**OHIO RIVER BRIDGES
SECTION 2 - DOWNTOWN BRIDGE
VALUE ENGINEERING STUDY REPORT**

Item Number 5-118.00

**Study Date: February 18 - 22, 2008
Report Date: March 7, 2008**

URS conducted a Value Engineering Study of the Louisville-Southern Indiana Ohio River Bridges, Section 2 – Downtown Bridge project. The topic was the 15% Design Development Submission prepared for the Kentucky Transportation Cabinet (KYTC) by Michael Baker, Jr., Inc.

**Use the Big 4 Railroad Bridge
for the Pedestrian Path
In lieu of using the new
Downtown River Bridge**

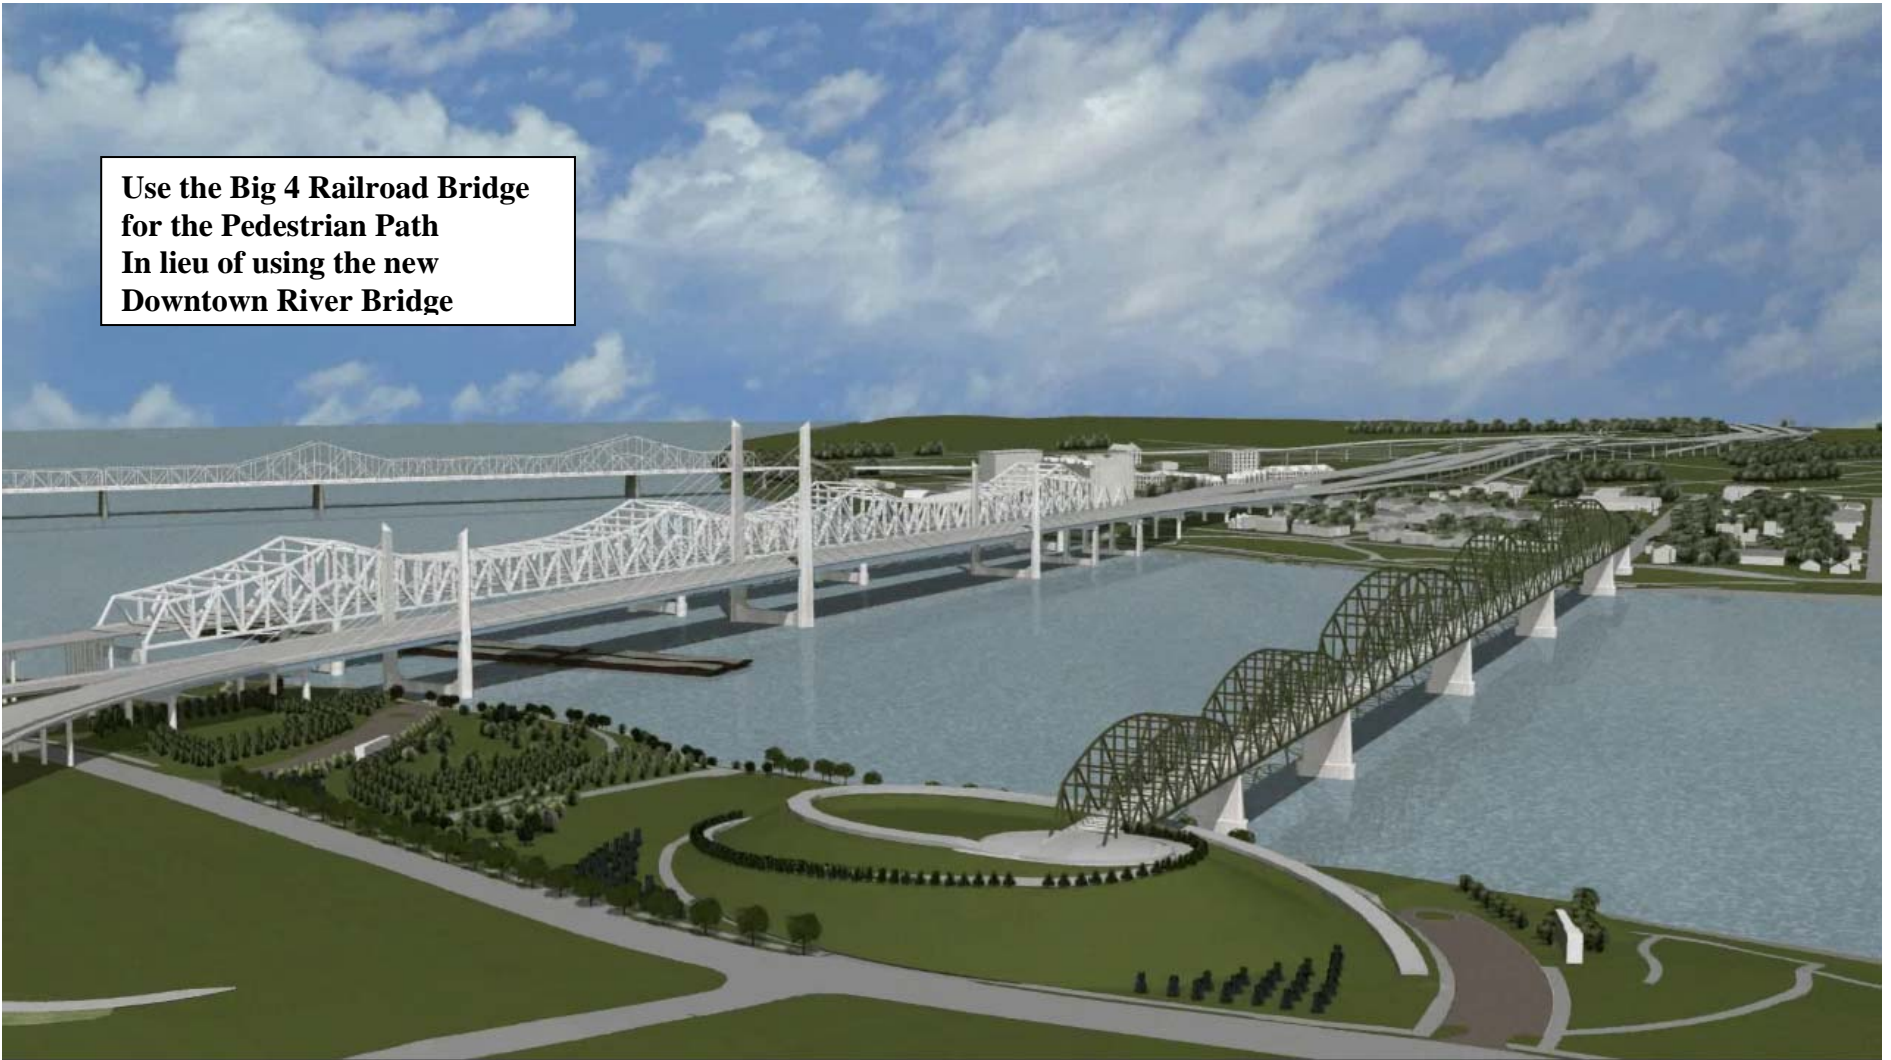
Utilize pedestrian path on Big 4 Railroad Bridge in lieu of on the new northbound Downtown Bridge.

The original design specifies constructing a 17 feet wide bike path and sidewalk along the upstream side of the new northbound I-65 Ohio River Bridge. This path will require superstructure construction to achieve elevation difference from the ground level up to the bridge on both the Indiana and the Kentucky side of the river. The pedestrian path makes the bridge 17 feet wider, and it requires the installation of 72 inch tall pedestrian guardrail/cage for the entire length of the bridge. This path has been designed to hold the weight of traffic, so the snooper truck or emergency vehicles could utilize it if necessary.

The VE team recommends utilizing a pedestrian path on Big 4 Railroad Bridge in lieu of on the new northbound Downtown Bridge. This will completely remove all associated pedestrian path elements from the new I-65 northbound bridge structure. The pedestrian path can utilize an earth embankment elevation or a structural ramp to reach the old railroad bridge. The Indiana side of the Big 4 Railroad Bridge will also need a ramp to the ground elevation. This project has already been designed and planned for construction.

- 3-SPAN CABLE STAYED CONFIGURATION (RECOMMENDATION)

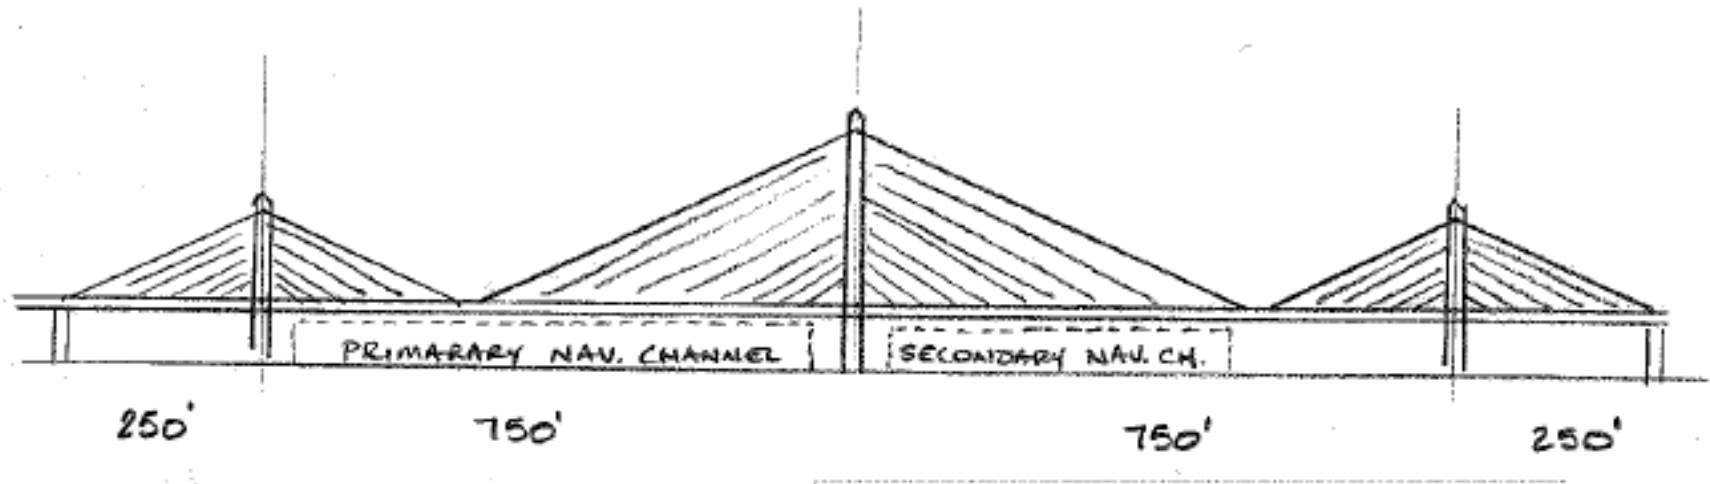
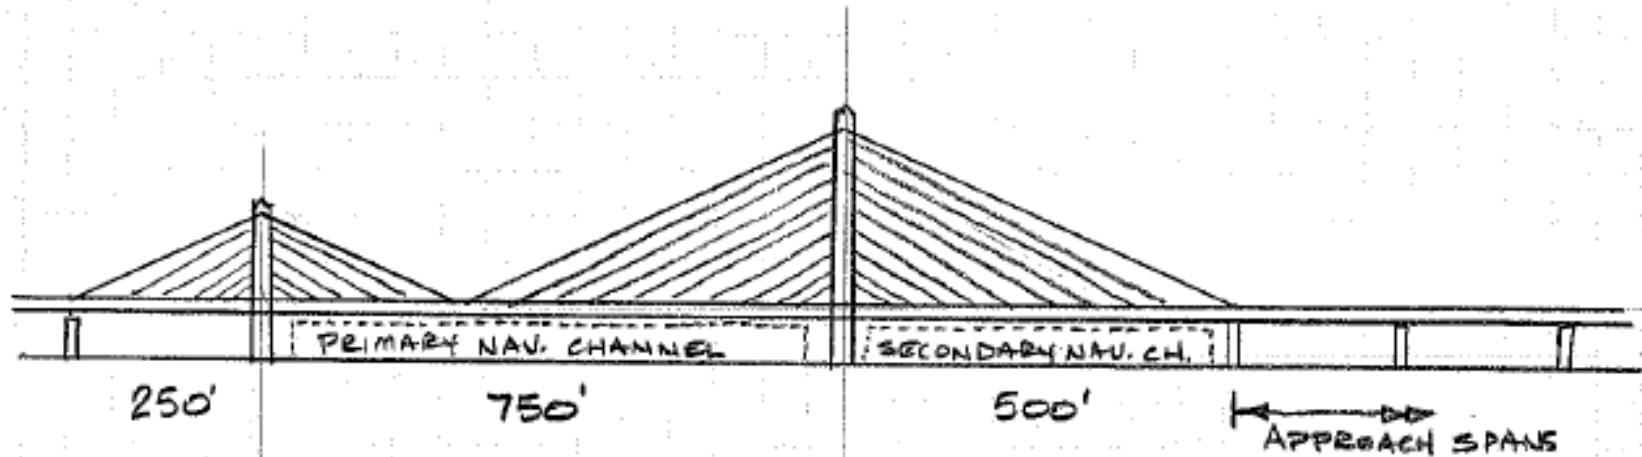
Eliminate Tower 5 and associated stay cables; reconfigure and extend approach spans on Indiana side (250-750-500 in lieu of 250-750-750-250).

Original design consists of a 4-span, three tower cable-stayed bridge with span lengths of 250'-750'-750'-250'. This four span arrangement provides a 750' clearance for the primary navigational channel and 750' clearance for the secondary navigational channel. The proposed Tower 4 is aligned with the existing JFK Bridge Pier 3; whereas, the proposed Tower 5 is not aligned with the existing JFK Bridge Pier 4 and is offset by 250'. The existing JFK Bridge provides a horizontal clearance of 680' for the primary navigational channel and 480' for the secondary navigational channel.

It is recommended to develop a more traditional 3-span, two tower cable stayed bridge in lieu of the 4-span cable stayed bridge. This 3-span bridge would be the most cost effective cable stayed arrangement that meets the functional requirements and will serve as a baseline for evaluating the cost premium associated with the current design.

For a traditional three span cable stayed bridge configuration, each of the towers has cables that go from the top of the tower to the anchor piers at both ends of the bridge. These back stay cables are generally large cables and act to stabilize the top of the tower from moving during vehicular loading on the mainspan. With the four span configuration shown in the Bridge Type Selection Report, the central tower does not have any back stays that can extend from the top of the tower to an anchor pier. All of the cables on both sides of this central tower are attached to a very flexible deck system. With this lack of backstays the top of the tower is not restrained which has several effects. First, the longitudinal moments in the central tower and foundations become large and require additional concrete, reinforcement and foundations to accommodate the forces. Second, the superstructure in the spans adjacent to this central tower may also experience additional deflections and demands due to live load.

Additionally, the four span arrangement provides a horizontal clearance that is much greater than the clearance provided by the adjacent JFK Bridge over the secondary navigational channel. It is recommended to consider a three span arrangement with span lengths of 250'-750'-500'. The 500' for Span 3 allows the new anchor pier to align with the existing JFK Bridge Pier 4 and maintains the same secondary navigational channel. The major advantage for the three span configuration is that both towers now have backstays that connect the top of the tower to anchor piers, thus providing stability and minimizing the flexural demand on both the tower and foundation. Second, the length of cable stayed bridge is reduced by 500' and replaced with simpler and more economical approach span structure.

To accommodate the three span cable stayed bridge the approach spans on the Indiana side will need to be lengthened by 500' and the span lengths reconfigured slightly. The increase in approach span bridge length will add an additional pier in the water which must be designed for barge collision forces; however, these foundations should not get too large considering the rock layer is close to the surface as you approach the Indiana river bank.

- 4-SPAN REVISED CABLE-STAYED CONFIGURATION

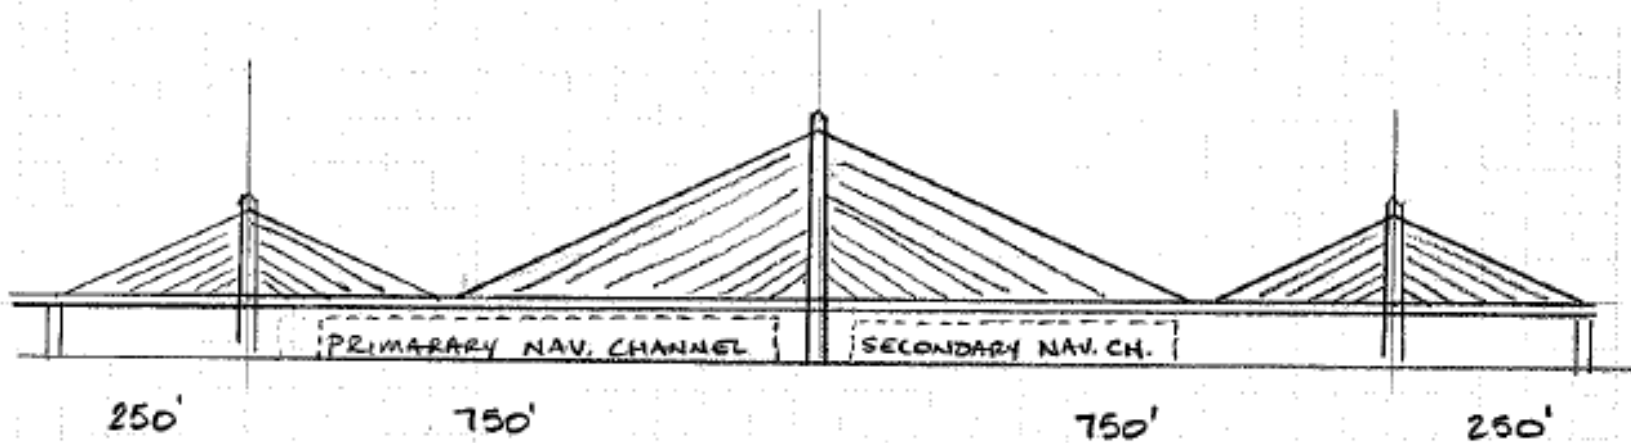
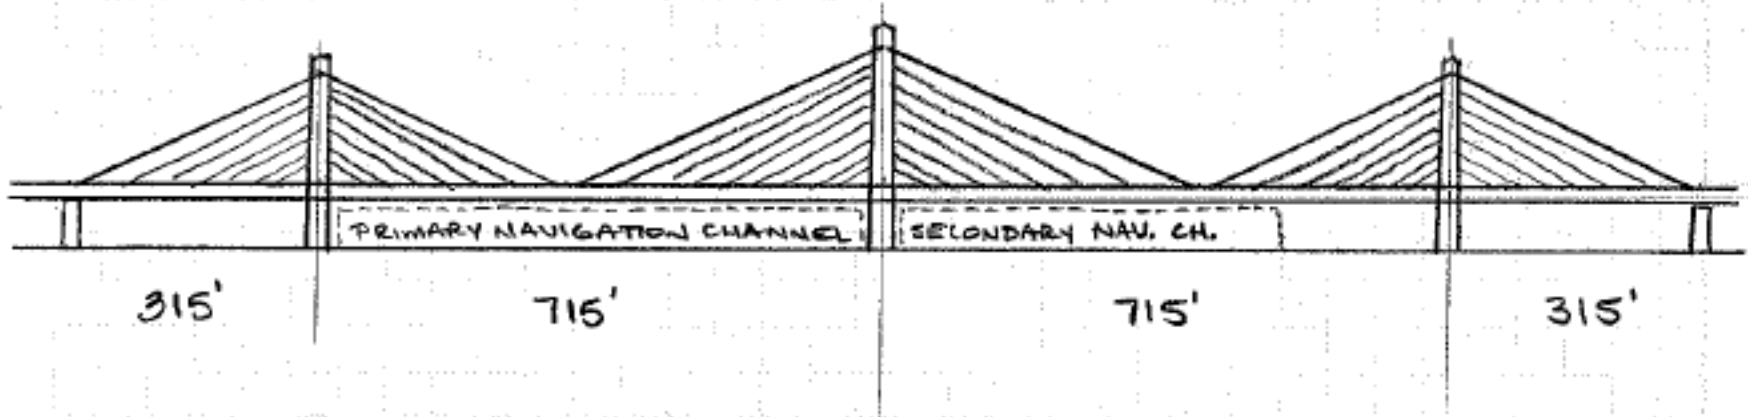
Reconfigure span lengths of proposed cable stayed bridge for more efficiency in design (315'-715'-715'-315' in lieu of 250'-750'-750'-250').

Maintain the proposed four span cable stayed configuration. However, adjust the span lengths to optimize the system for reduced cost and better structural performance.

Tower 4 will remain in alignment with the JFK Bridge Pier 3. Span 3 will be reduced to 715' which places Tower 3 at the edge of the primary navigation channel and in alignment with the JFK Bridge Pier 2. Span 4 will also be reduced to 715' which provides more than adequate horizontal clearance for the secondary navigation channel. The lengths of Spans 2 and 5 will be increased to 315'. This results in a total length of cable stayed structure of 2060' compared to the original concept of 2000'.

This adjustment of the cable stayed span lengths will also reduce the length of Span 1 from 200' to 170'. Likewise, the length of approach spans on the Indiana side can be reduced by 30'.

Relocate Pier 8 closer to Riverside Drive to eliminate potential for barge impact.

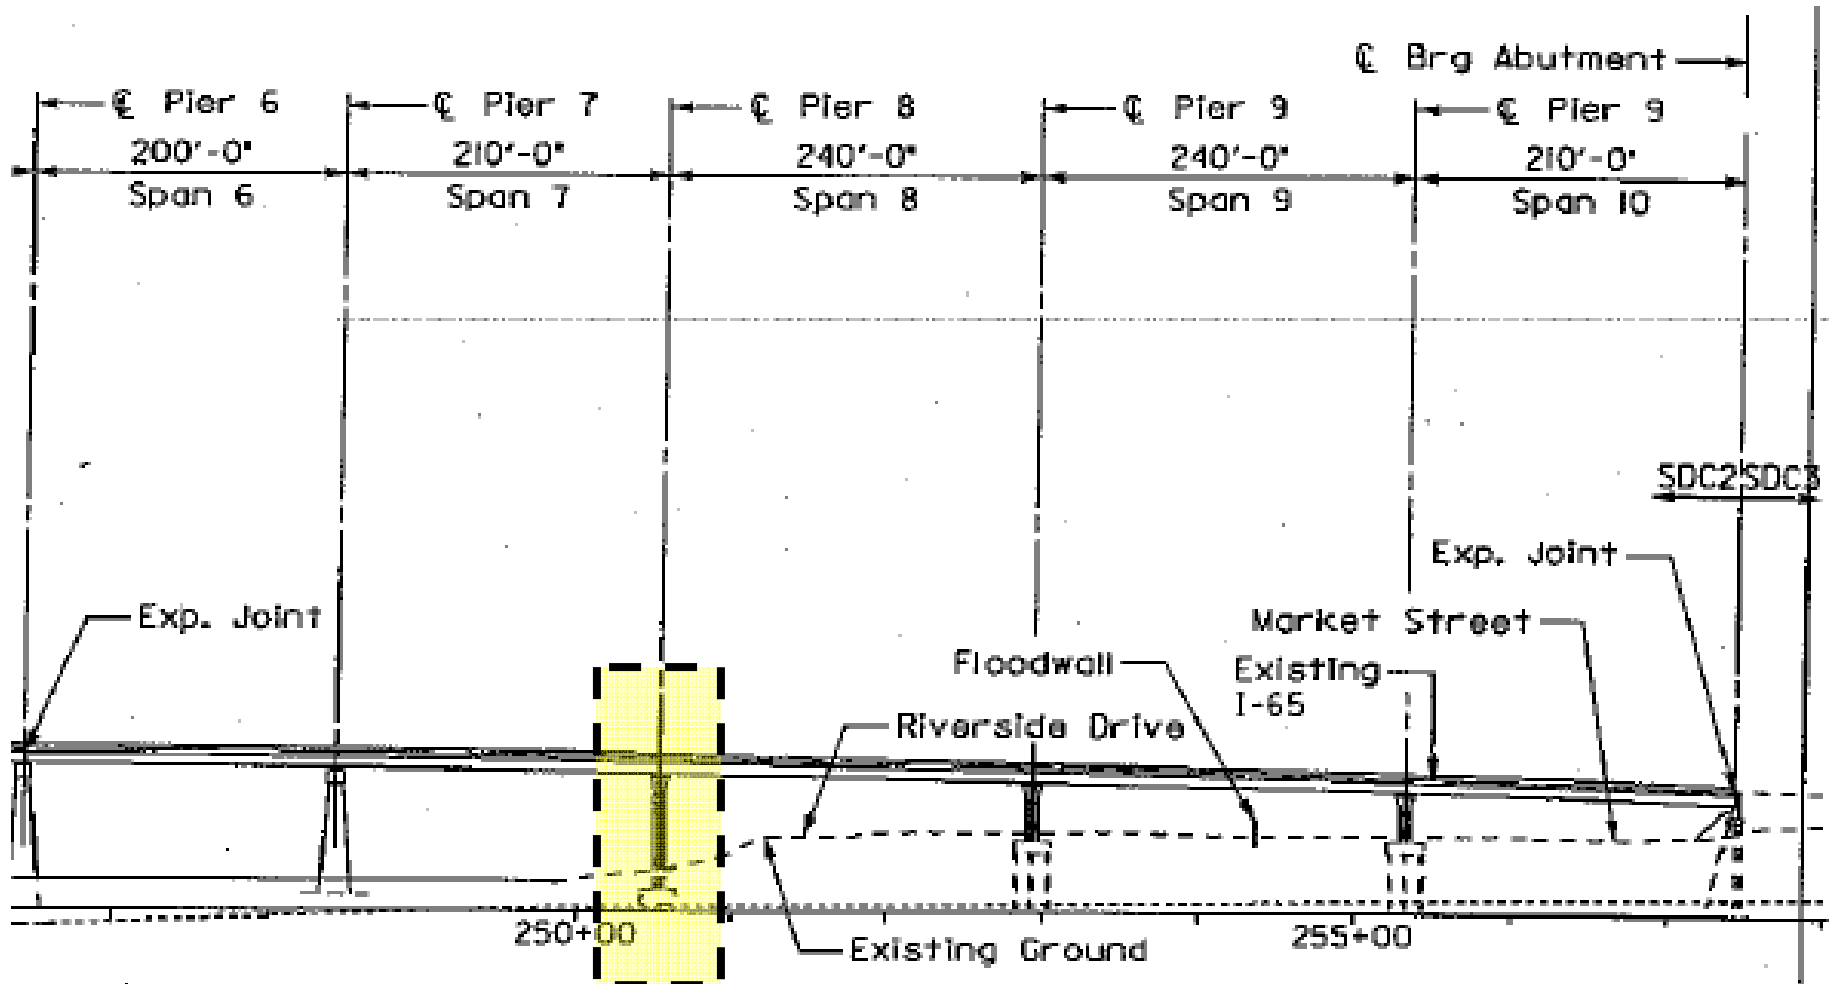
The Indiana approach spans as configured in the Bridge Type Selection Report places Pier 8 on the river bank during Normal Pool water levels. However, during high water events the pier is in the water and is vulnerable to barge impacts.

Consider moving Pier 8 to the north and placing it closer to Riverside Drive where the ground elevation is higher and therefore the potential for barge collisions is reduced or eliminated. This also has the beneficial effect of reducing the length of Spans 8 and 9 which are currently set at 240'-0".

Move Tower 3 closer to edge of primary navigation channel.

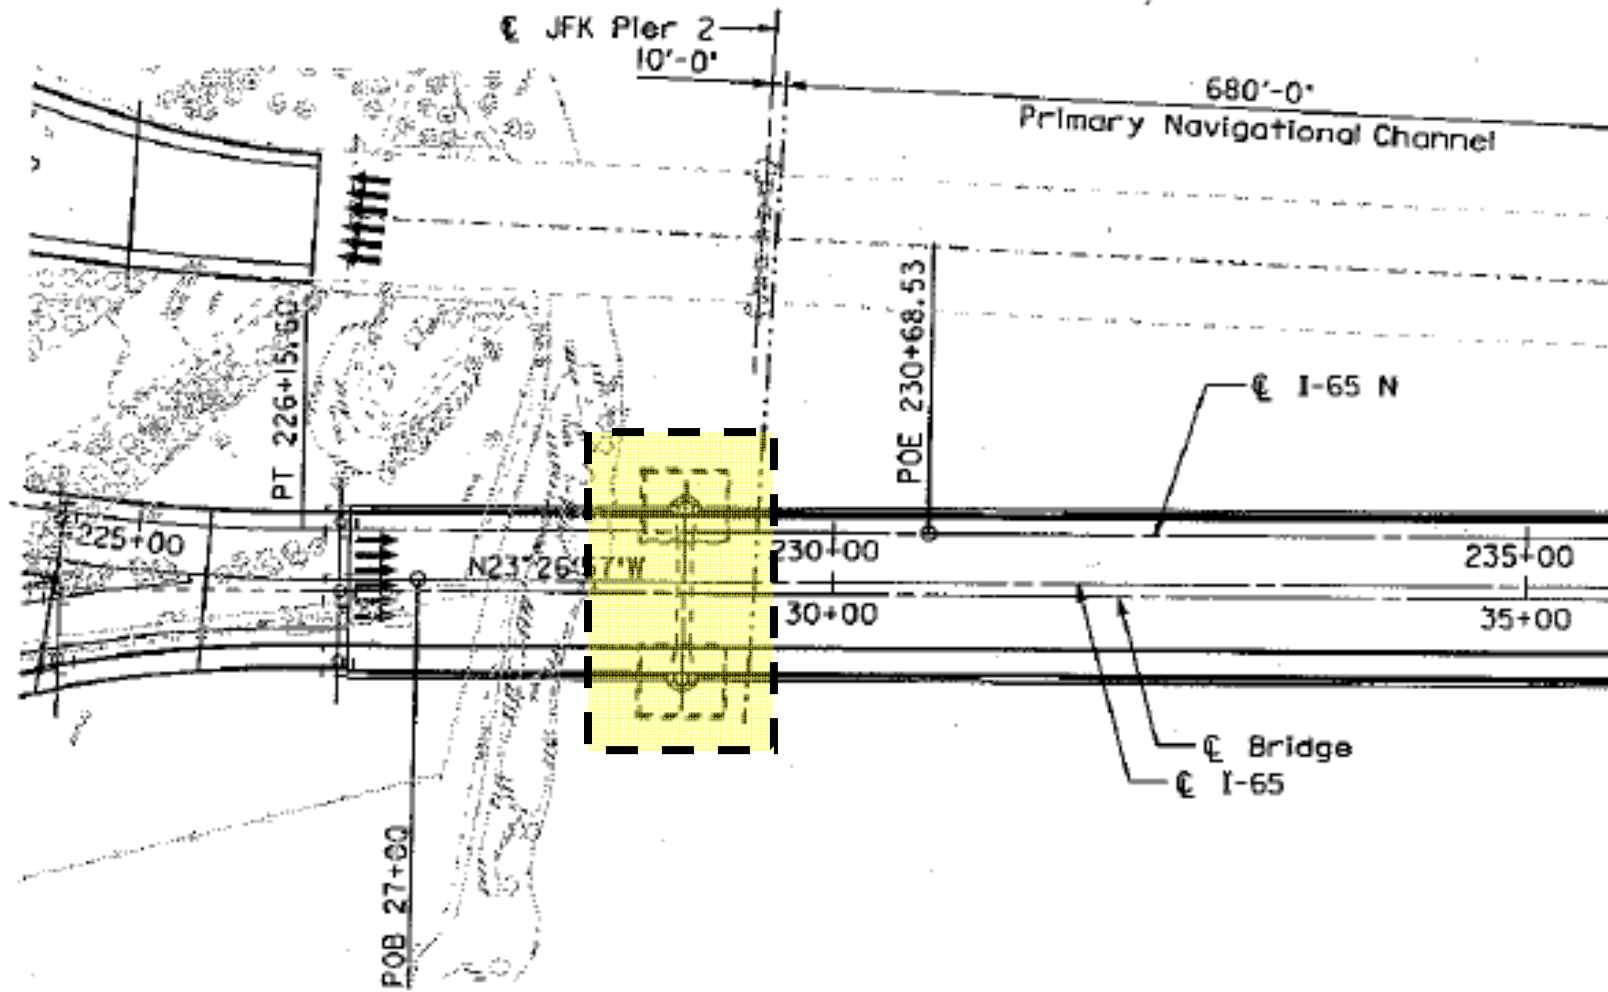
The current cable stayed bridge configuration proposed in the Bridge Type Selection Report has the edge of Tower 3 located approximately 35' clear space to the edge of the primary navigation channel. Consideration should be given to moving Tower 3 to the north by approximately 35' and placing the tower leg adjacent to the primary navigation channel. This Design Comment is in conjunction with VE Recommendation 5 which proposes a length of 715' for Span 3.
